**Please add the following: 3rd review**

LOT BOUNDARY

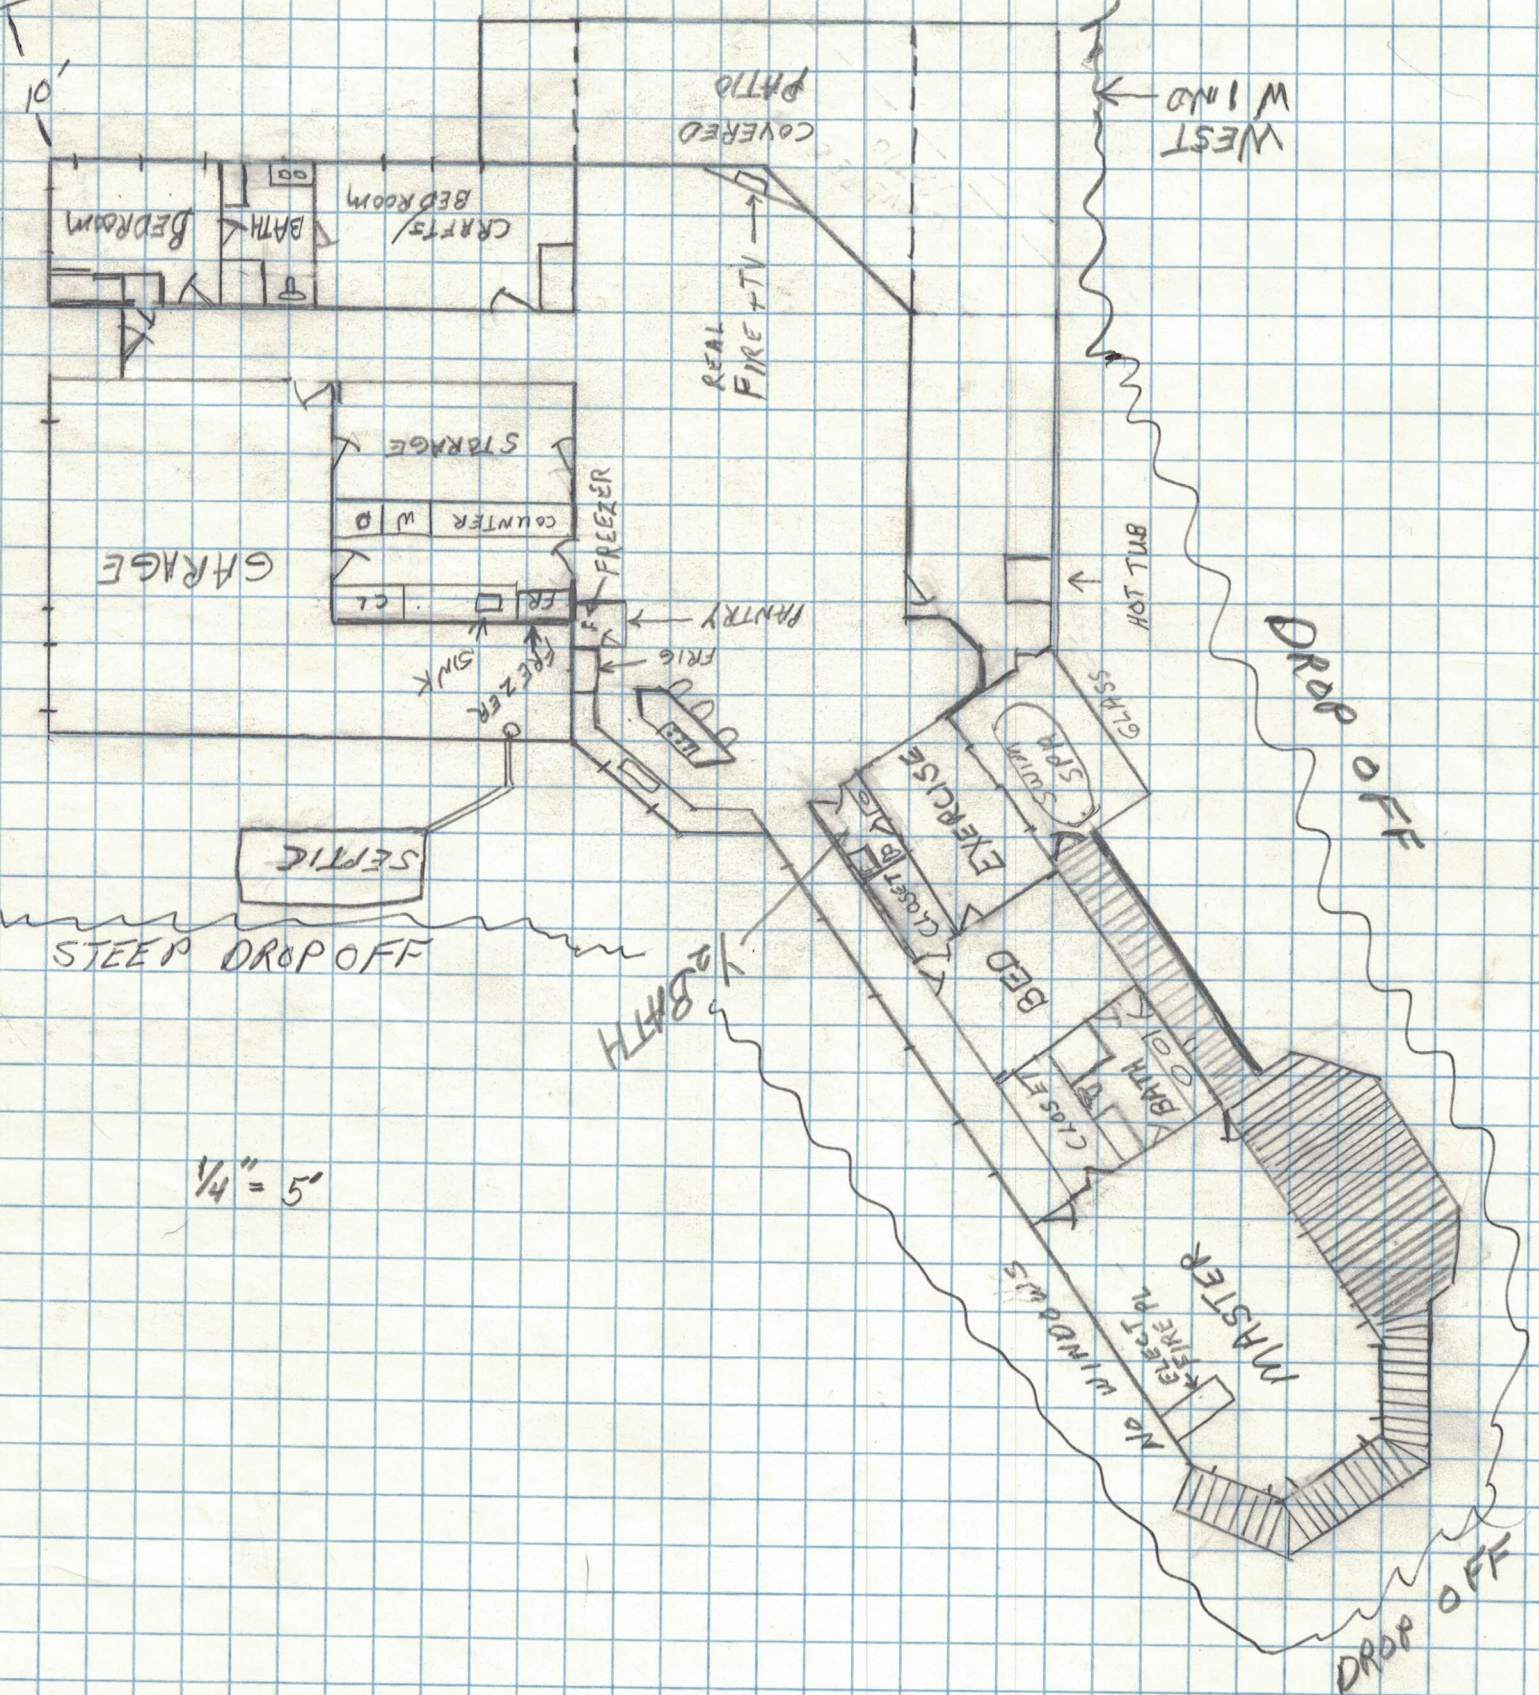
- Please contact Engineering to discuss before resubmitting. They want you to utilize the site plan from the second submittal and just update it as requested. Please include the items listed below from the 2nd review on this drawing:

- Owner name, contact telephone number and email
- Applicant name, contact number and email
- Property address
- Property tax schedule number
- Legal description
- Lot size
- Lot area coverage calculation
- Current zoning of property
- Add the square footage of the proposed home
- Add setback distances from the proposed home and all property lines
- Include any driveways
- Location of all existing and proposed utility lines

- Please show all easements on the property. Per title commitment submitted by applicant there is a utility easement alongside Northfield Road. Please see document for reference.
